Video Products Technical Bulletin 30-2003-096

DATE: March 24, 2003 SUBJECT: V JITTER AT H/V DELAY

MODEL: PVM-14L4

Figure 1

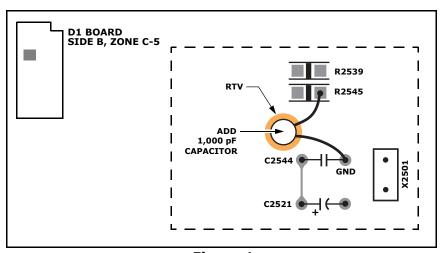
Noise may enter V.SYNC at H/V delay, which may destabilize the delay time of IC2504, causing V jitter. To correct the symptom, perform the following modification procedure.

D1 Board (Side B, Zone C-5)

1. Add a 1,000 pF capacitor between ground and the junction of R2545 and C2513 (1 μ F/10V) of the input to IC2504. (See Figure 1.)

2. Affix the capacitor to the board with RTV.

Figure 2

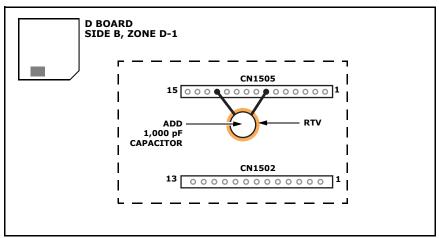
D Board (Side B, Zone D-1)

If the part number of the D1 board is 1-682-404-11, modify the D board as follows:

1. Add a 1,000 pF capacitor to CN1505 between pins 12 and 7. (See Figure 2.)

2. Affix the capacitor to the board with RTV.
